**Albuquerque
Metropolitan
Arroyo
Flood
Control
Authority**

Re: Drainage Management and Construction Plans for APS Community Stadium
Engineer's Seal Dated 12-21-11

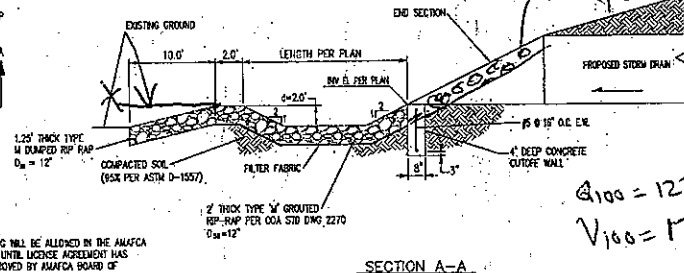
1. Basins 15, 16 and 17 are going to Ladera Dam (LD) 5. In the DAR, these basins are the eastern third of Basin UD.4B, which was going to LD 4. I don't think this change will have significant impact, but it should be shown with flow arrows on DMP-002 (see attached) and noted in the narrative on Sheet DMP-001.
2. Basins 2-14 are going to LD 3. In the DAR, these basins are the western two-thirds of Basin UD.4B, which was going to LD 4. This change may have some impact on the storage volume of LD 3. I would like this evaluated by Craig Hoover, who prepared the DAR, and a recommendation from him whether or not this change warrants a re-evaluation of the LD system hydraulic analysis. This change should also be shown with flow arrows on DMP-002 and noted in the narrative on Sheet DMP-001

STORM DRAIN OUTFALL RIP-RAP EROSION CONTROL

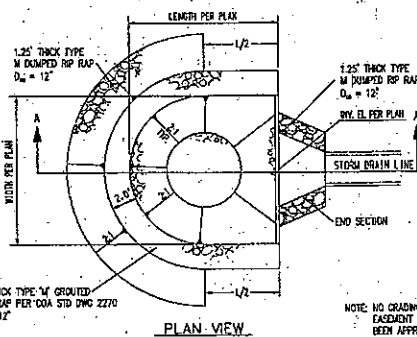
1. On Sheet C-107, there needs to be a base course access road to MH 12 and the water quality manhole.
2. On Sheet C-190, the 10-foot riprap extension should be buried. The intent is to prevent headcutting at the horizontal section (see attached). Also, the riprap around the pipe outlet should extend at least to the top of pipe. We often see erosion around pipe outlets.
